## ERRATUM: ANALYSIS OF A CONTROLLER-BASED ALL-DIGITAL PHASE-LOCKED LOOP

[Published in Volume 15, Number 1 (2015)

Pages 57-73 of the
Far East Journal of Electronics and Communications]

The following sentences in the pages 69, 70, 71 should be corrected and Figure 5 should be replaced as follows.

**Figure 5.** (a) Frequency step of the reference clock, (b) ADPLL output frequency response with frequency division (N=32) for the reference frequency step, and (c) step responses of  $H_{cln}(z)$  and  $H_{cln}(s)$  with the extracted simulation parameters.

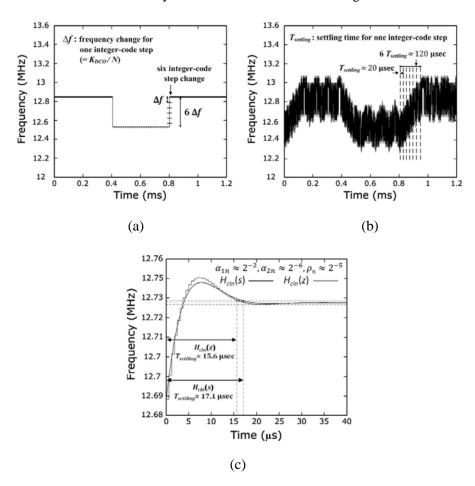
This paper was published online in July, 2015 [Volume 15, Number 1, Pages 57-73]. In this paper, we performed modeling and analysis of a controller-based all-digital phase-locked loop (ADPLL). However, we made a mistake in the calculation of the step response of the ADPLL to validate the model using behavior-level simulation.

Page 70, line 1: "... code with time to reduce the phase error is shown in Figure 4(c) as decimal variation. Figure 5(a) shows the frequency step of the reference clock corresponding to a step change of six DCO integer-code, which can show enough change in ADPLL output frequency over frequency variation. By considering this large frequency step as combination of small one integer-code step, the small-signal approximation used in equations (3) and (4) can still be validated. As shown in Figure 5(b), the output frequency settling to a step change of one integer-code is around 20 $\mu$ sec. The  $K_{DCO}$ from simulations is about 1.6MHz/code change (=  $3.2\pi$  Mrps/code change), and the  $K_{PPF+PI}$  is  $2\pi/64$  for the 64-phase..."

Page 71, line 10: "... settling times of 15.6µsec and 17.1µsec which are close to the settling time simulated using the behavior-level simulation  $(T_{\text{setting}} \approx 20 \mu \text{sec})$ ".

The corrected Figure 5 is shown as below.
